### SOUTH CAROLINA ELECTRIC & GAS COMPANY Operations RCG Meeting

# INFLOW DATASET DEVELOPMENT: STATISTICAL METHODOLOGY

## PARR HYDROELECTRIC PROJECT

Comments regarding Kleinschmidt's "Inflow Dataset Development: Statistical Methodology" for the Parr Hydroelectric project (FERC No. 1894).

FIGURE 2 MONTHLY AVERAGE FLOWS, UNADJUSTED

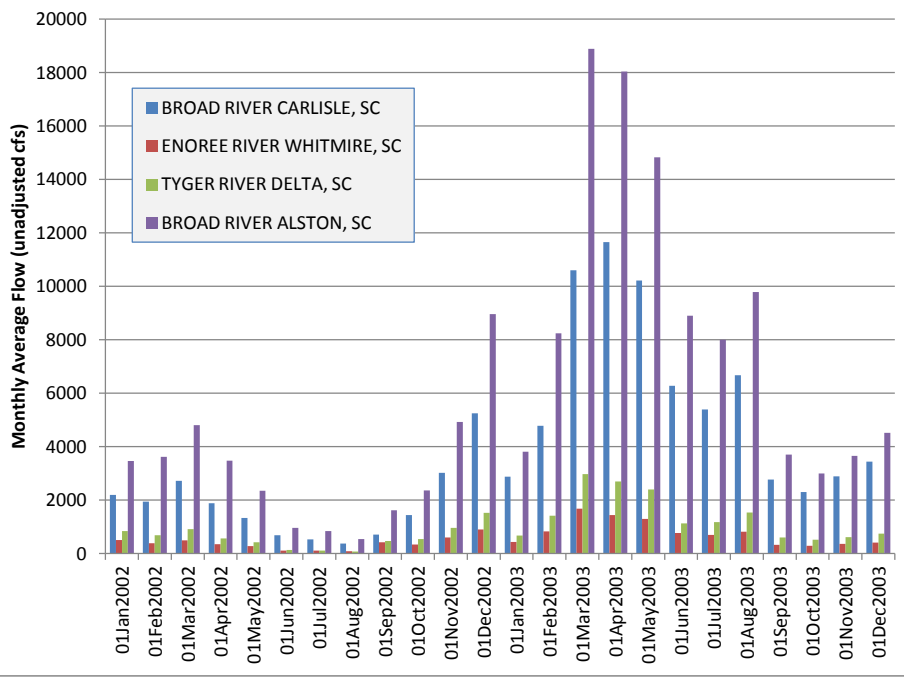
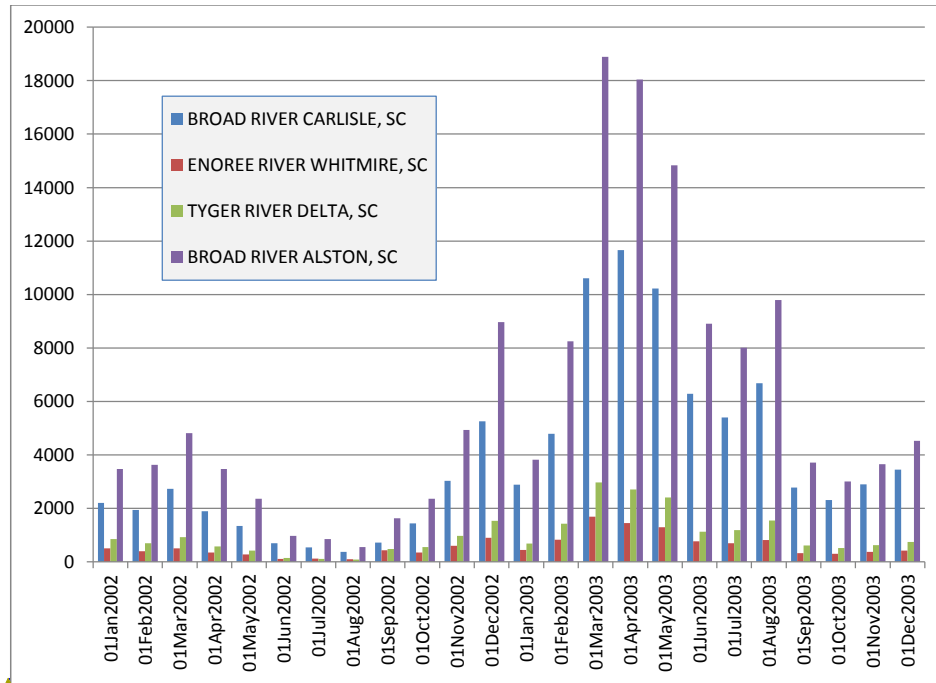
Comment: *Y axis label = unadjusted Q* (regarding the Figure 2 Monthly Average Flows column chart)

Answer: Agreed, Label Added to Chart in final version.

FIGURE 3 NORMALIZED MONTHLY AVERAGE FLOWS

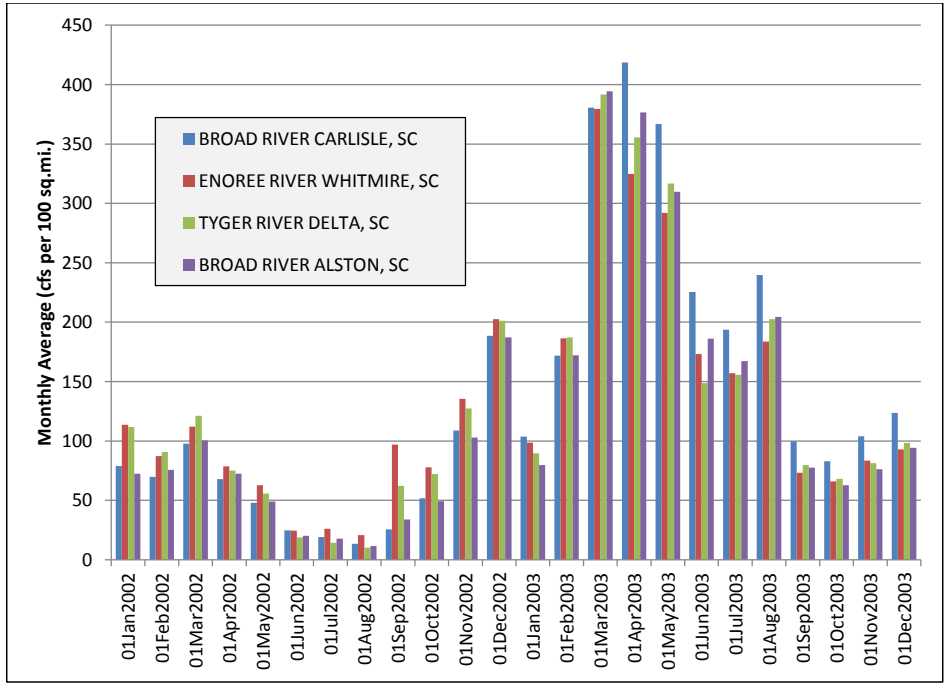
a. Only two years were used for comparison (2002 and 2003) in Figure 3. Was there an attempt to include more years? These two years represent extremes, or close to it, for dry and wet years back to back and the comparison would be more robust if it included more normal periods as well or if a comparison was made for a longer period of time (see below also).

b. Please rewrite or elaborate on the following statement at the end of page 6: "The comparison (see [Figure 3](#)) illustrates that the range of the monthly averages (per 100 sq. mi.) was visually close to the aggregate average through a variety of flow ranges; this indicates the hydrologic similarity of the three subbasins." Please consider summarizing the point you are trying to make here quantitatively in a table and not just visually from a plot. In Figure 3, normalized monthly average runoff is consistently higher for the Broad basin in 2003 than for the Tyger and Enoree, which maybe isn't surprising given that the Broad is a much larger basin that extends up into the North Carolina mountains. It would be instructive to see if this was observed for other years besides 2003 (my own preliminary analysis shows that it does). The higher runoff suggests that the assumption of homogeneity for the gaged portion of Broad basin (as a whole) at Carlisle as compared to the Enoree and Tyger basins may not be valid. As a result, it may be problematic to use the Broad River gage at Carlisle to develop a regional coefficient. However, I think that the assumption that the *ungaged* parts of the three basins (Tyger, Enoree, and Broad) are very nearly homogeneous is likely valid, but the question remains on how to best account for the additional flow from these ungaged areas (but see 4 below).

"The comparison (see [Figure 3](#)) illustrates that the range of the monthly averages (per 100 sq. mi.) was visually close to the aggregate average through a variety of flow ranges; this indicates the hydrologic similarity of the three subbasins."

*BH: Is there a benefit of normalizing discharge by 100 sq. mi. versus normalizing by 1 sq. mi.?*

*BH: Was this the sole period of record [referring to Figure 3, Normalized Monthly Average Flows, which shows 2002 – 2003 calendar years] used to infer similarity of runoff characteristics among subwatersheds? According to table 1 there are overlapping discharge data for all of these gages since 1973.*

*There appear to be potentially significant differences in mean monthly discharge between gages even when the data is normalized by drainage area.*

The comparison of normalized flows for evaluating hydrologic similarity was performed using the monthly average flows for the period 1/1/1981 to 12/31/2013, a thirty-two year period. Only two years were charted for the document for visibility, selected to illustrate consistent gaged contributions across a

range of hydrologic conditions: extreme drought conditions during the summer of 2002, and high inflows the following spring. We can present additional years for comparison, and propose to include them in appendices. Our conclusions apply to the entire period of record and range of flows.

Visual examination of the normalized flows was done to check for consistent, significant discrepancies between gaged areas under a range of hydrologic conditions. The comparison of any single normalized gage with the aggregate average was visibly within the same order of magnitude for all months across a large range of inflow conditions, and was the basis for concluding the similarity. The Carlisle gage does appear to contribute more flow more often, but to a nominal degree compared to the aggregate. In the interest of simplicity, consistent regional coefficients were used for the analysis.

Answer: The scale for normalizing was selected to match the order of magnitude of the contributing (smallest) drainage area. Examining the three gages on a cfs per unit square mile would not change the results or the relative contribution of any gage area, but only the scale. The lower flows would change from around 10 cfs/100 square miles to 0.1 cfs/square mile, while the higher 420 cfs/100 square miles would reduce to 4.2 cfs/square mile.

Answer: Visual examination of the normalized flows was done to check for consistent, significant discrepancies between gaged areas under a range of hydrologic conditions. The comparison of any single normalized gage with the aggregate average was visibly within the same order of magnitude for all months across a large range of inflow conditions, and was the basis for concluding the similarity. While any given month may show one gaged area has a

noticeably higher contribution, no general trend indicates a consistent bias across the range of hydrologic conditions. Significant differences in runoff characteristics would be indicated by one or more normalized areas consistently contributing more or less than the aggregate average. In the absence of significant consistent contribution by any single gage, consistent fitted regional coefficients (alpha and lambda) were selected for all three gaged areas. Variances observed for individual months, where one gaged area contributes more or less than others, is attributable to precipitation that was inconsistent for the entire drainage area, rather than differences in runoff characteristics.

Answer: The period of record used to infer similarity was 1981 – 2013, the longest concurrent period for the four gages available (in complete calendar years); the Alston Gage period of record has a gap in the dataset from 1907 through 1980. We will correct the current period of record in Table 1 in the final version. Only two years were charted for the document for visibility, selected to illustrate consistent gaged contributions across a range of hydrologic conditions: extreme drought conditions during the summer of 2002, and high inflows the following spring.

**FIGURE 6 ALSTON FLOW (ADJUSTED) VS. PREDICTED MONTHLY AVERAGES (33 YEARS) - REGRESSION BASED ON DRIEST 75% MONTHS**

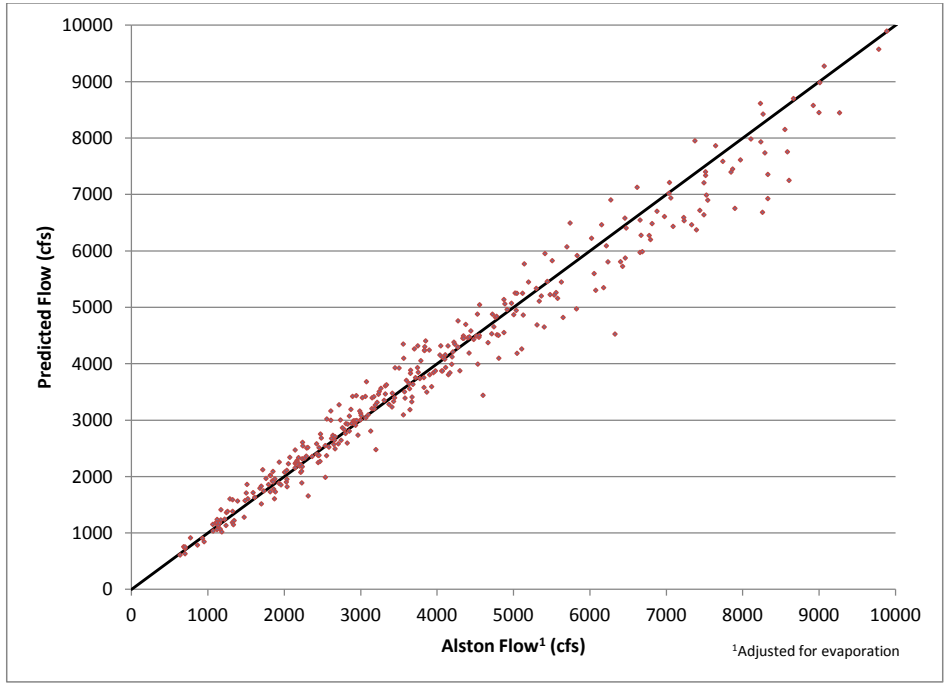
*Figure 6 shows a few stray data points that may be driving up SE. Were any statistical outliers omitted from analysis?*

The Standard Error represents the standard deviation across the entire range of flows. The Standard Error on the left and right columns are based on the associated regional coefficient and exponent, which were established according to the conditions of the headings (all flows vs. lower 75% flows, approximately 6,000 cfs limit). The Standard Error for only low-flow scenarios would have lower values. The Standard Error calculated for flows up to 6,000 cfs is 321 for the left column, and 304 for the right column. The Relative Standard Error of the entire dataset more accurately explains the error versus the total range of flows. For both regressions, the RSE is calculated at 9.3%.

No statistical outliers were omitted from the analysis, as the good correlation between the predicted and measured flows across the range of data did not suggest that data points needed eliminated.

**FIGURE 1 (EXPANDED) ALSTON FLOW VS. PREDICTED MONTHLY AVERAGES (33 YEARS)  
– REGRESSION BASED ON ALL MONTHS**

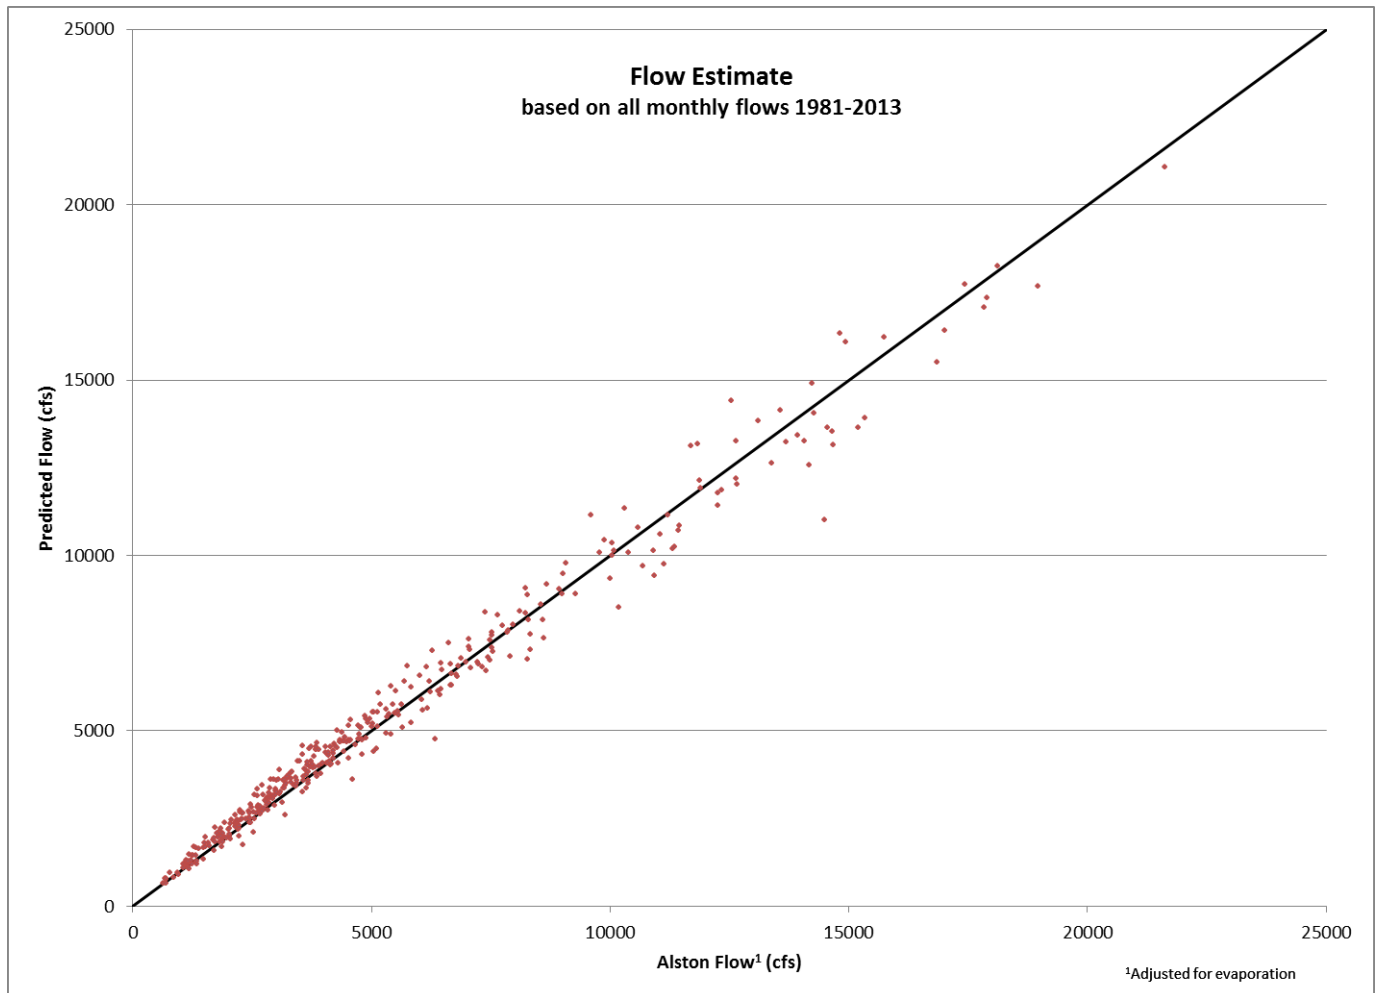
3. In section 1.3.2, please make sure that the x and y axes scales are set to display all data points in Figures 4 and 5. For example, in figure 4, average flows at Alston extend well beyond 10,000 cfs for some months, but the maximum flow is cutoff somewhere between 9000-9500 cfs.

**FIGURE 1 MODEL RESIDUALS - REGRESSION BASED ON 75% LOWEST FLOW AVERAGE MONTHS**

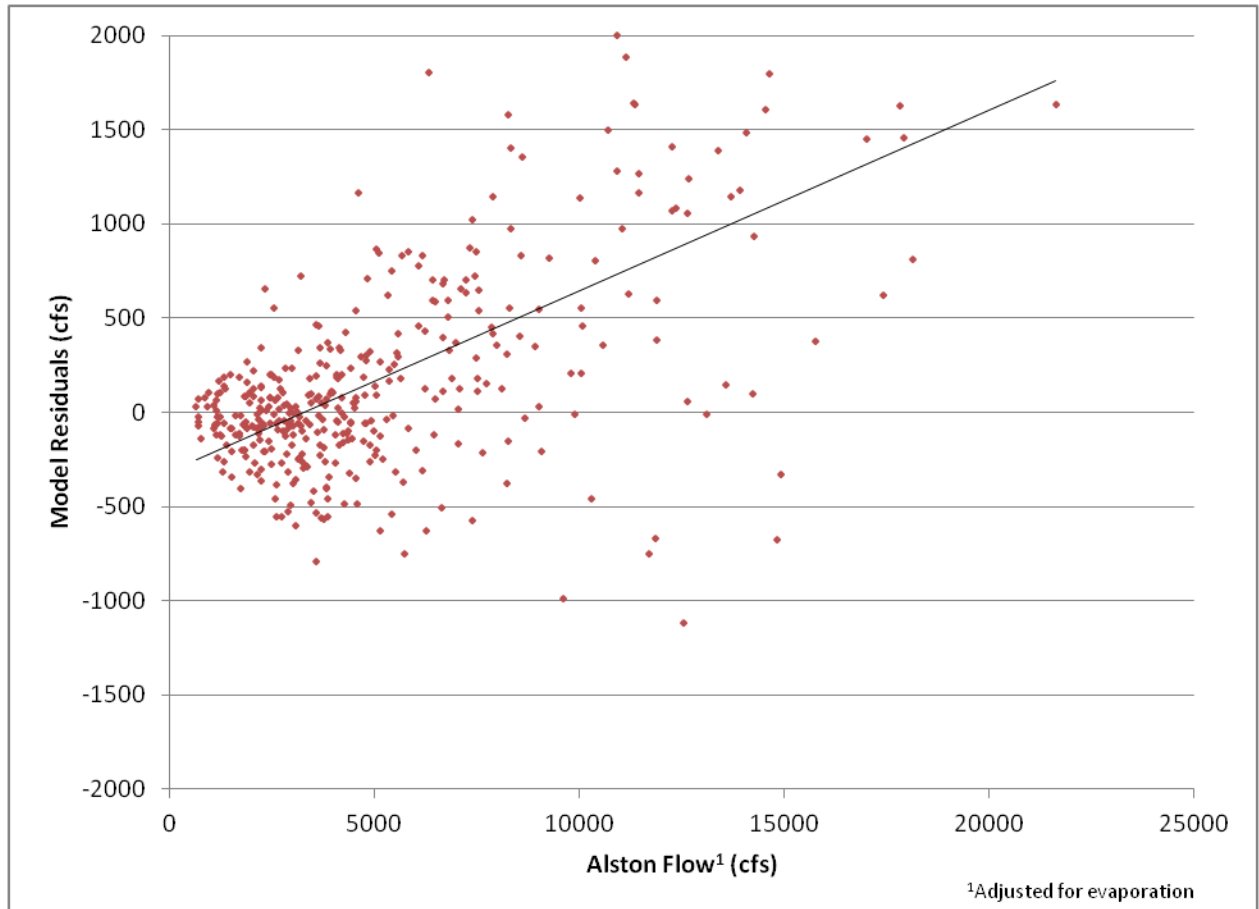
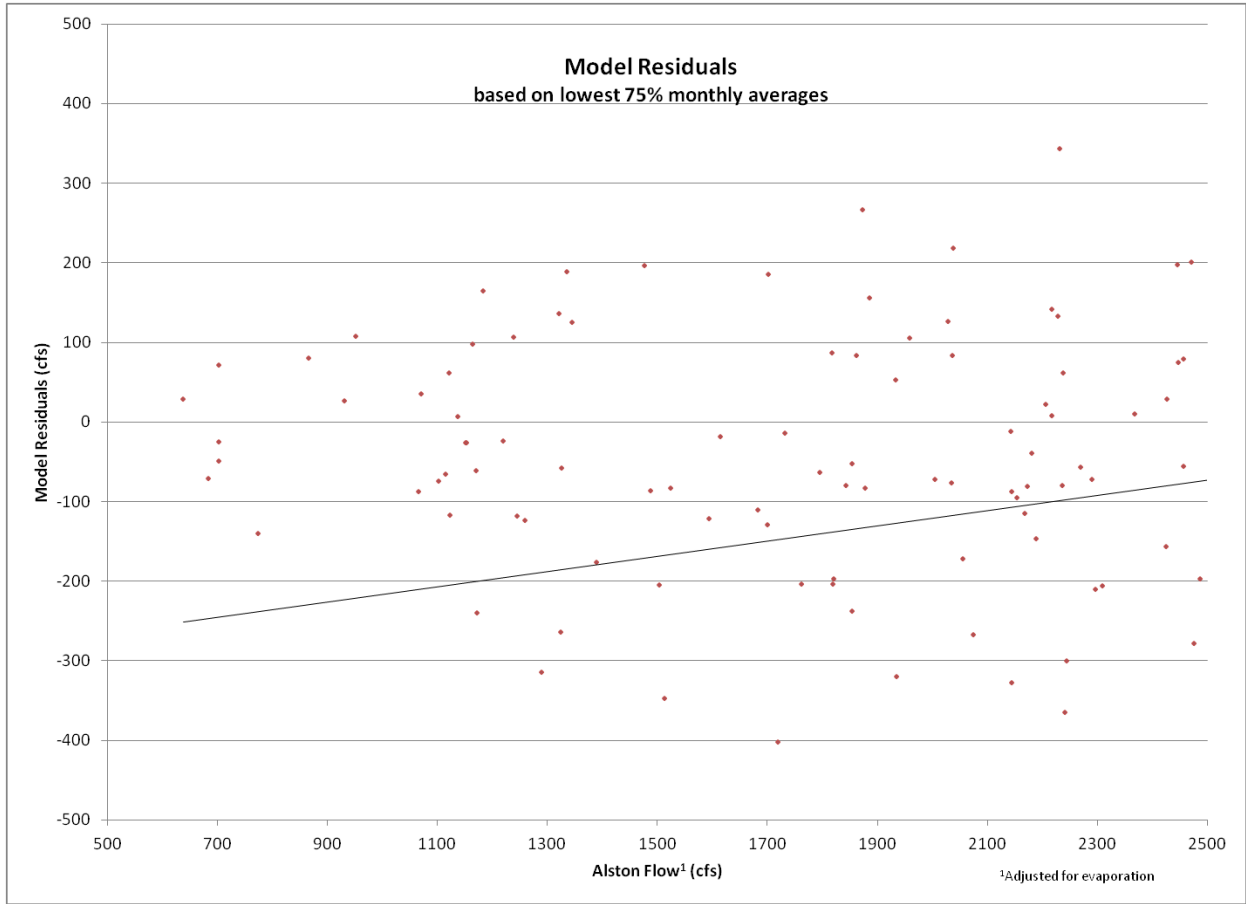
*GJ: Poor fit at lower end of flow range affects the reliability of the model*

The residuals diminish in magnitude as flows decrease, and appear evenly distributed about the zero value. While the inflow dataset will have calculated values both higher and lower than the Alston readings, no significant bias is evident under low flow conditions. A closer examination of the low-end flows can be made with the graph below, scaled to flows below 2500 cfs. (The trendline is a linear average across all flows for the 75% lower inflow months, and does not represent the trend of the lower flow residuals alone.)
